**ADDENDUM NO. 2  
ISSUED: JUNE 10, 2024**

**PROJECT: CITY OF ABILENE  
GRIMES WTP IMPROVEMENTS  
CONTRACT NO. 1 – FILTER MEDIA REPLACEMENT / ABILENE PROJECT  
No. CB-2450**

FILTER SECTION

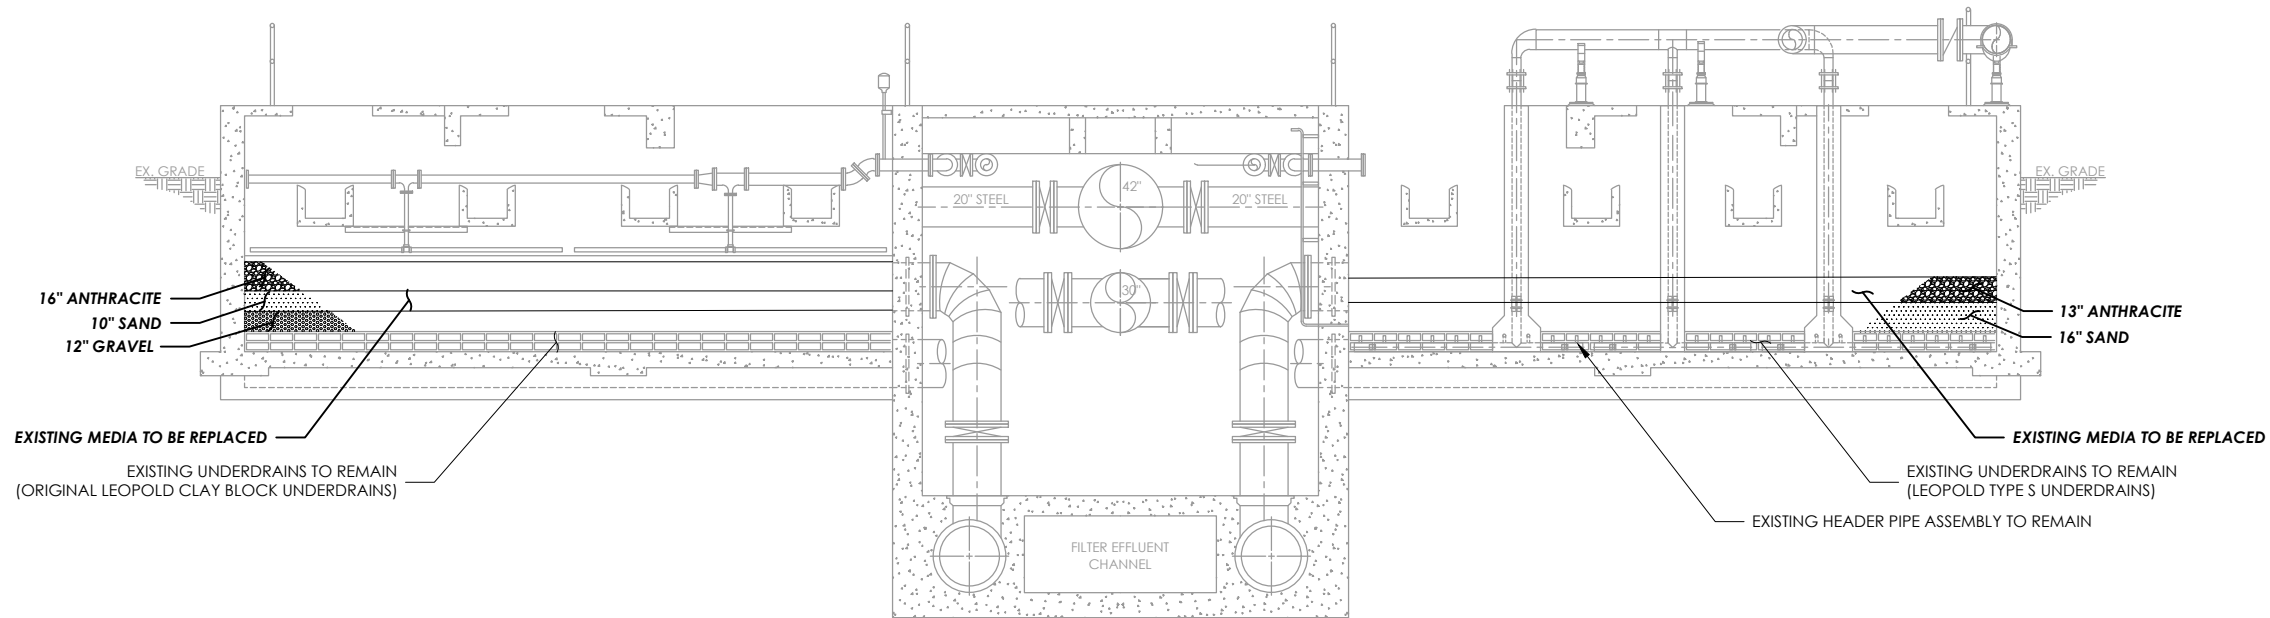
- 1. Sheet 04 has been revised. Replace Sheet 04 with the attached plan sheet.
